CONTRACT 26016

Building and Site Improvements at 6741 Downing Avenue, Bakersfield, CA

Bidder's Request for Information Responses #9

August 4, 2026

A100 Site Plan

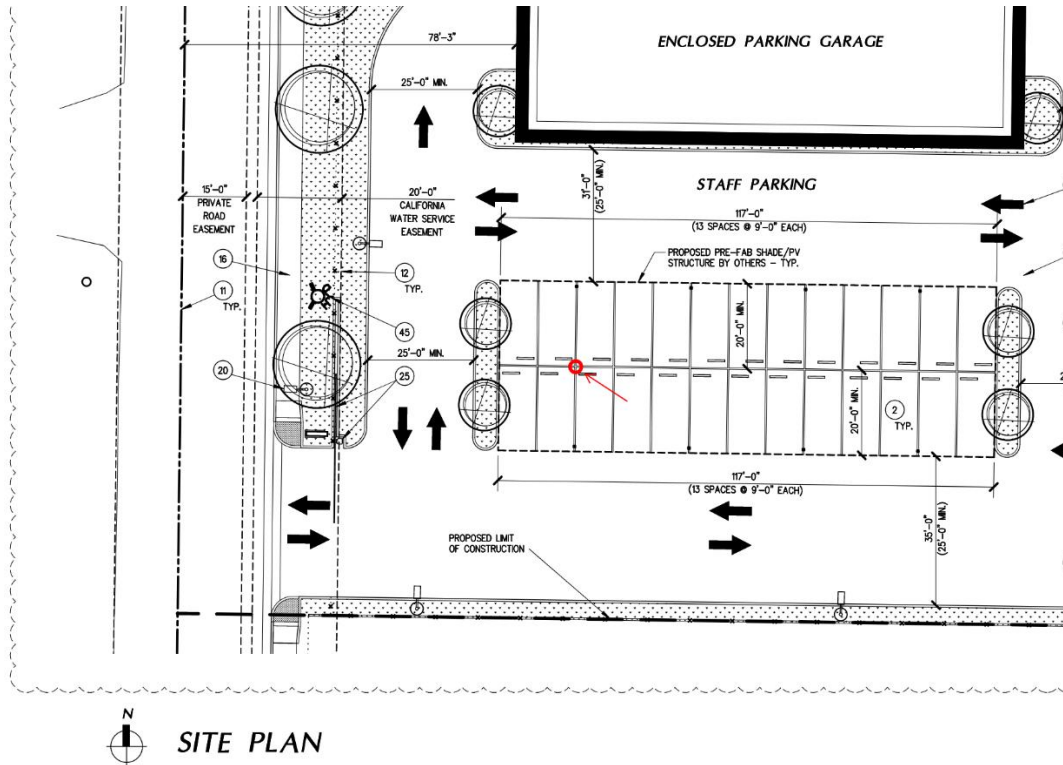
There is one light that is called out to be at the parking spaces SW of the parking garage, and the photometric light plan coincides with this. However, there is no symbol for the light being there. Not to mention that the PV carport, under a separate permit, would conflict with this light pole, as it would need to be removed to install the carport. Will it be removed from the scope, or is it going to be installed, to only later be removed by the contractor that installs the carport?

This pole mounted light location is accurate. This location shall be added to sheet E100A under an addendum. Sheets A100B and C2A shall also be provided to show accurate pole-mounted lighting locations.
